**DEPARTMENT OF DEVELOPMENT SERVICES – PLANNING DIVISION**  
**REPORT: Inland Wetlands & Watercourses Permit, 2 Maxim Rd.**  
for consideration September 22, 2020

**STAFF REPORT**

**PROJECT:** Bridge Construction at  
2 Maxim Rd.  
PARCEL ID: 315-693-002  
ENERGOV ID: P&Z-COMM-2020-0156

**TYP. STRINGER SECTION: HP 12 x 53**

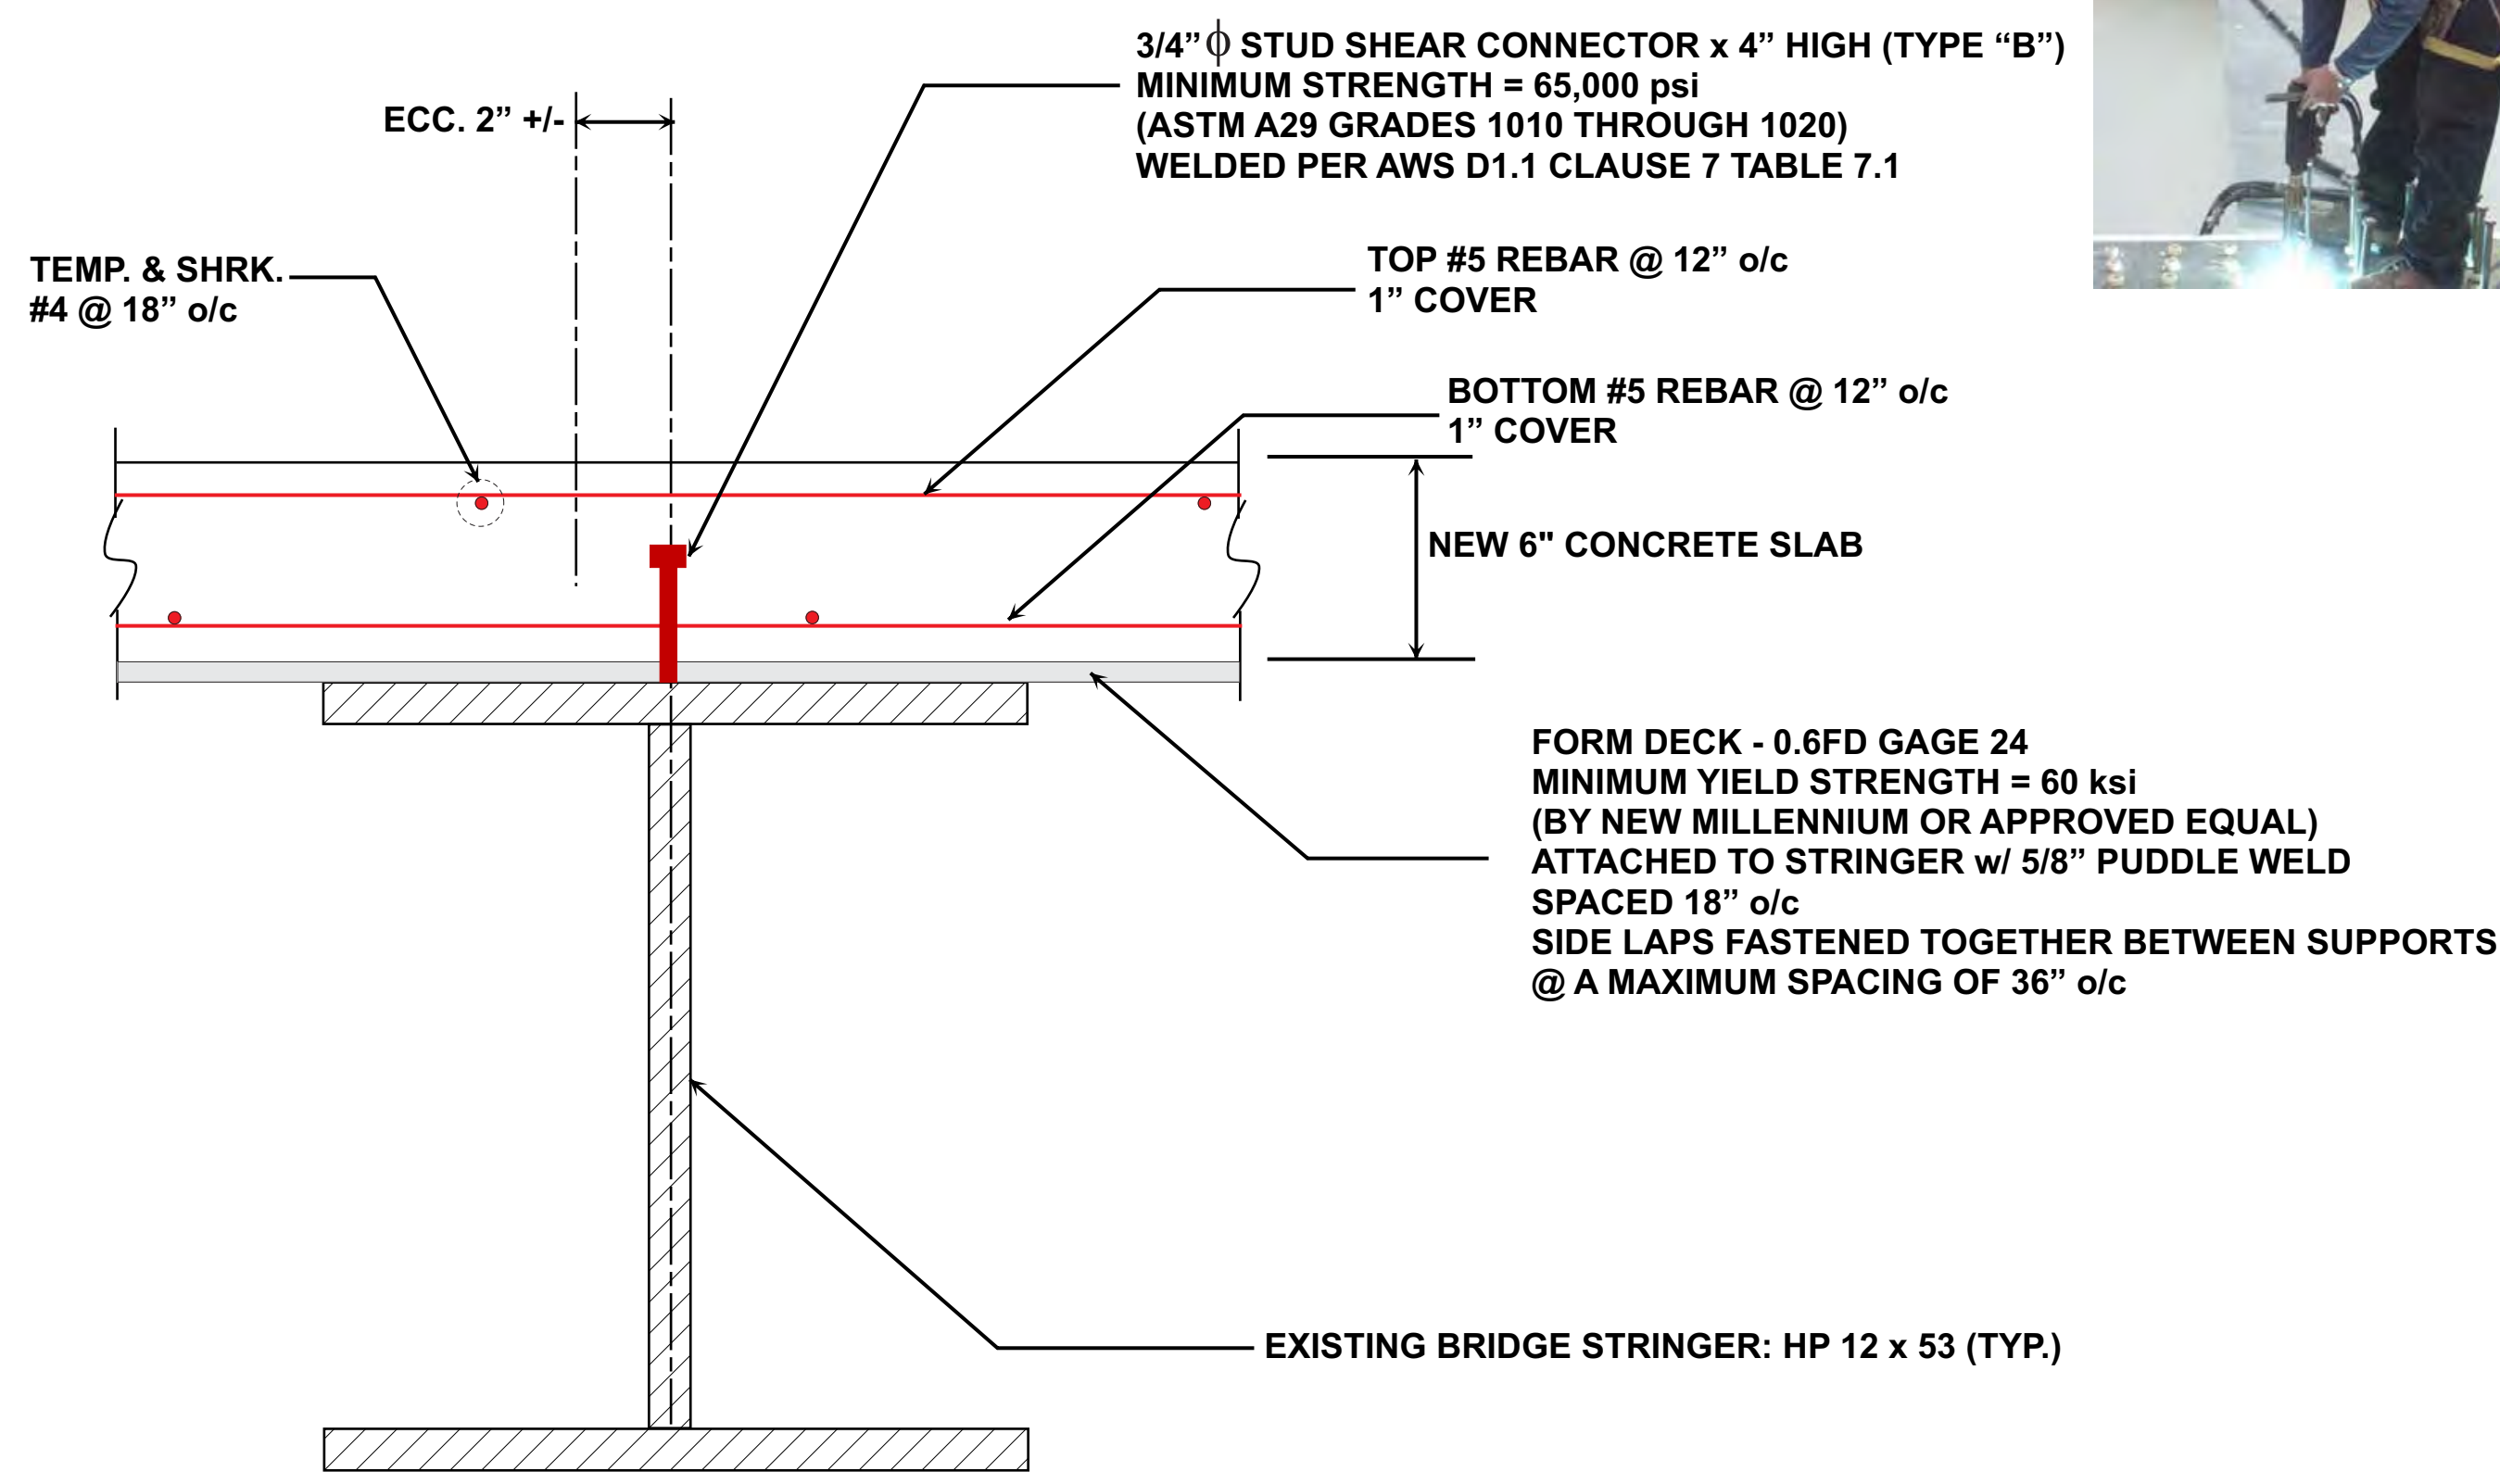
- Structural Design Drawing of the bridge, certified by a structural engineer, indicating design will withstand the loads of the intended users (dump trucks, heavy equipment, etc.)
  - Include a cross-section at the wetlands/watercourse crossing.

- Revised Site Plan to include the following:
  - Modifications to proposed bridge, designed/certified by a structural engineer

The set stringers will require the top flange to be laterally braced at midspan to prevent lateral buckling and meet the bending strength requirement. The lateral bracing would be accomplished by welding the boundary 6" deep channel around the concrete deck to the stringers.

At each abutment the stringers should be ties together (cross frame / diaphragm) to prevent axial rotation (twisting) of the stringers on the bearing support.

The bridge is existing and has been inspected by a Connecticut licensed structural engineer. He has completed a 14 page report and a two page plan showing the bridge to be structurally sound and having the load capacity to support large heavy truck traffic. The bridge will need a concrete deck which will be poured in place to be complete. We will obtain a building permit to pour the concrete deck prior to any work being started.

See Structural Engineers Plan

PROPERTY SURVEY & SITE PLAN - PROPERTY OF 2 MAXIM ROAD LLC - 2 MAXIM ROAD - HARTFORD, CONNECTICUT - SCALE: 1" = 30' - DATE: 2/18/16 - REVISED THRU 10/11/15 - BY CLOSE, JENSON & MILLER

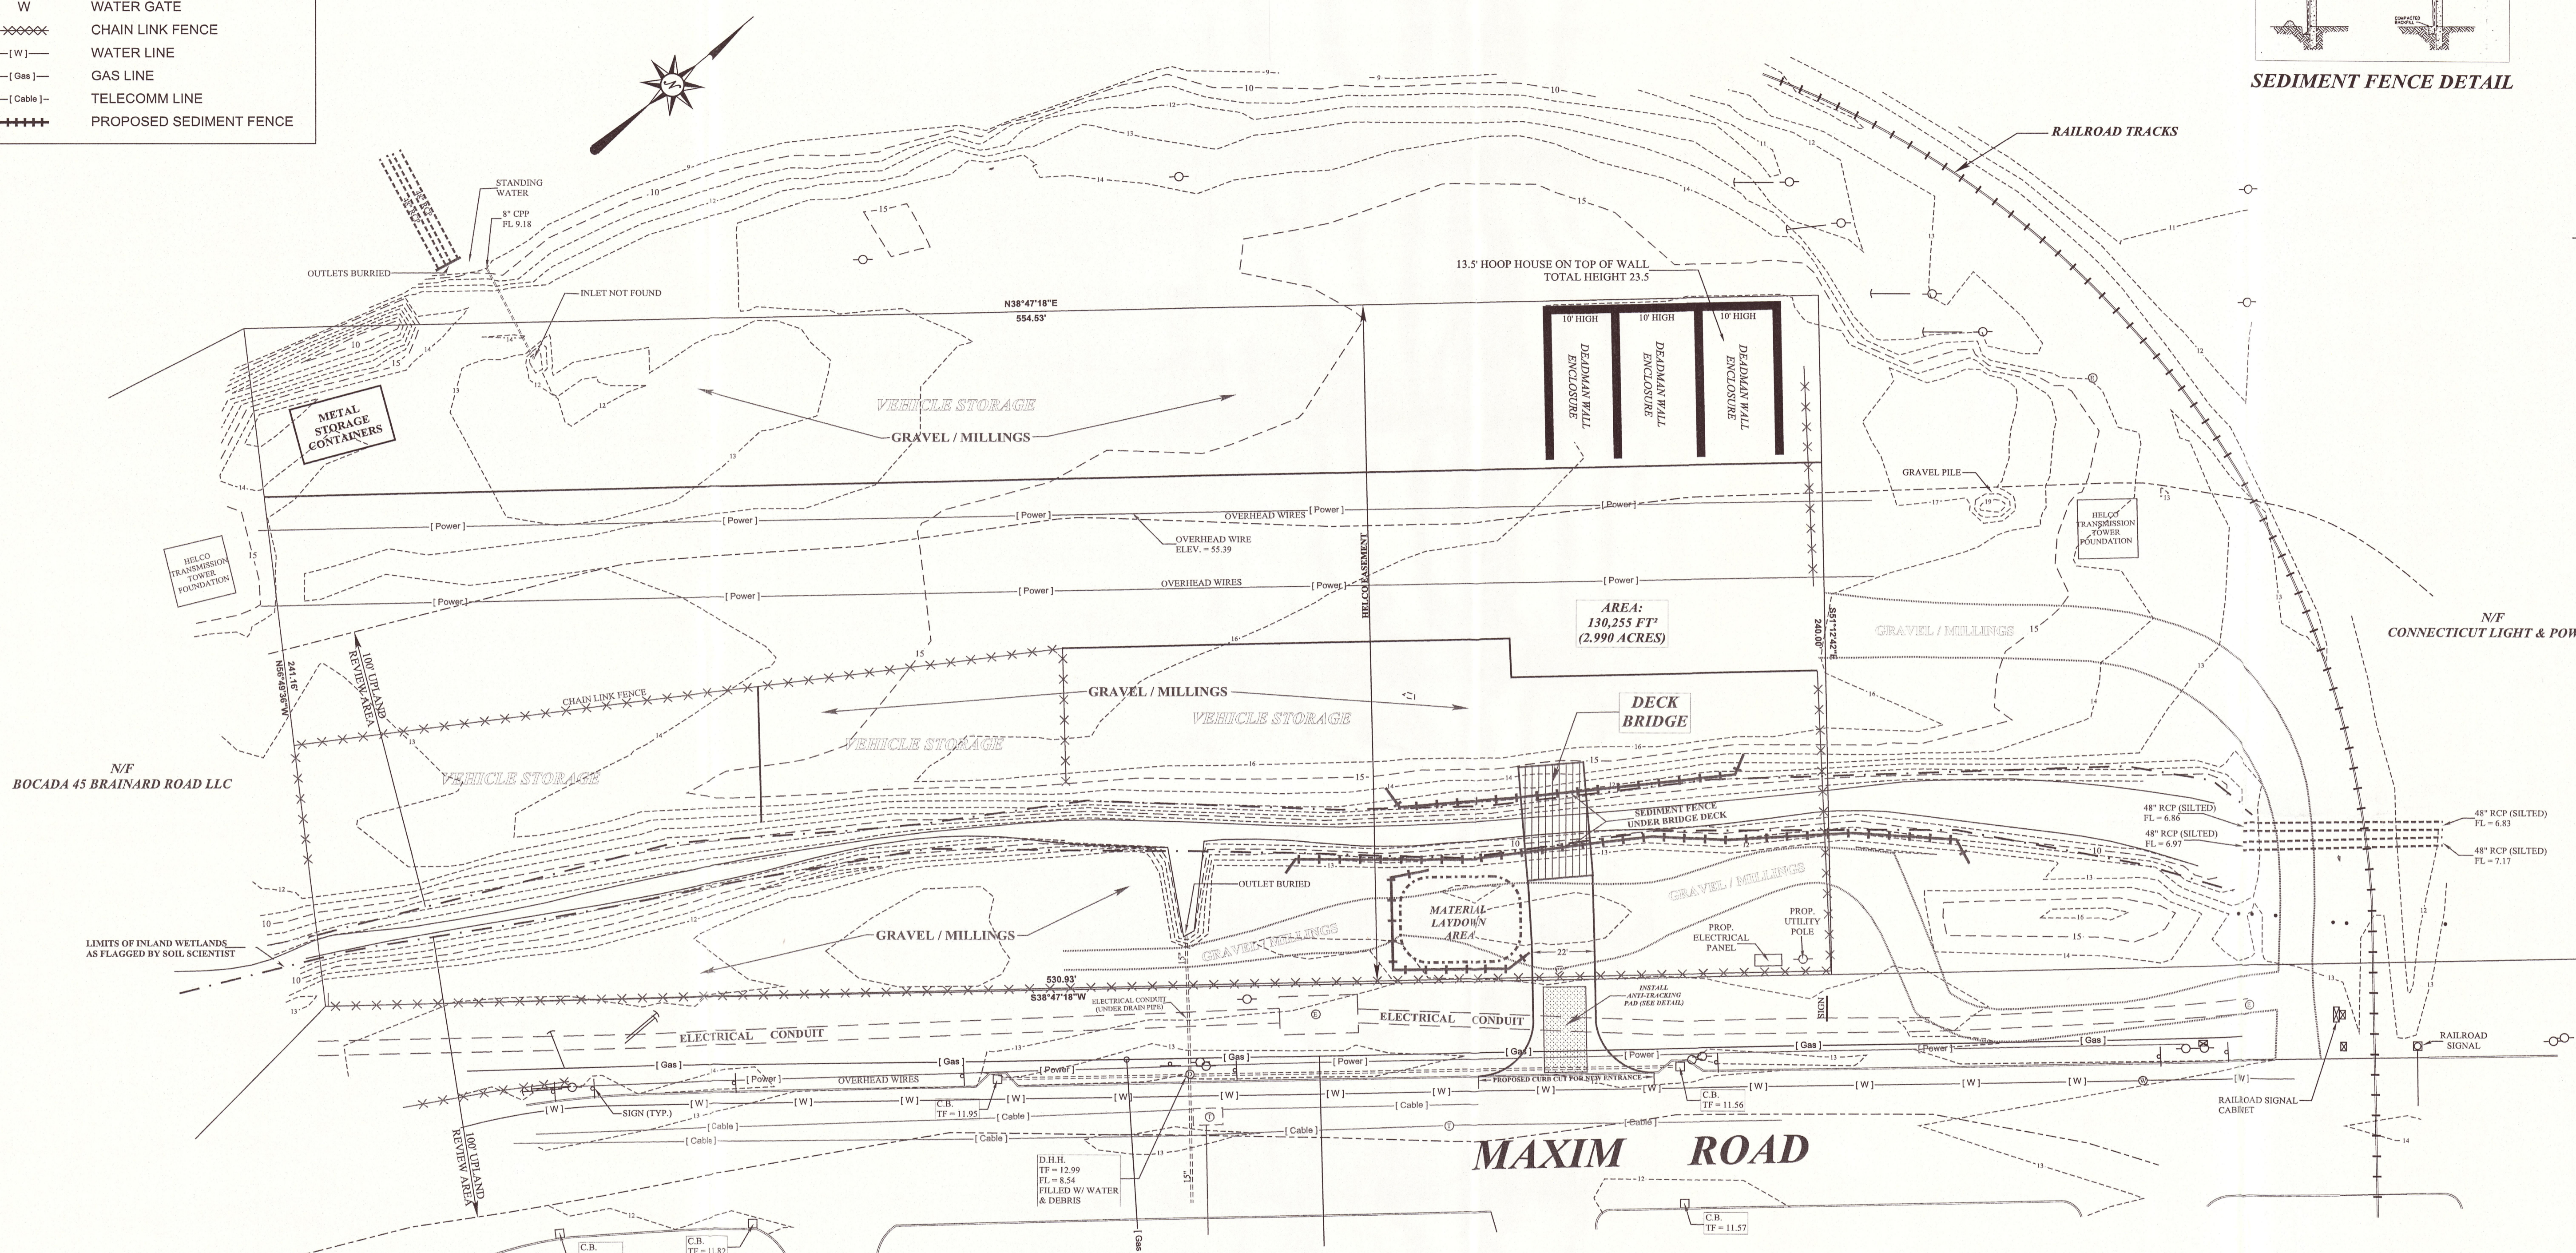
- An Erosion & Sedimentation Control Plan has not been provided (required to complete this application, per Sec. 7.5.(e) of the Inland Wetlands & Watercourses Regulations (the “Wetlands Regulations”))

- **Provide an Erosion & Sedimentation Control Plan signed/sealed by a professional engineer.**
  - **Indicate how the wetlands and adjacent properties/streets will be protected from erosion throughout development activities.**

Will be on Erosion & Sedimentation Plan
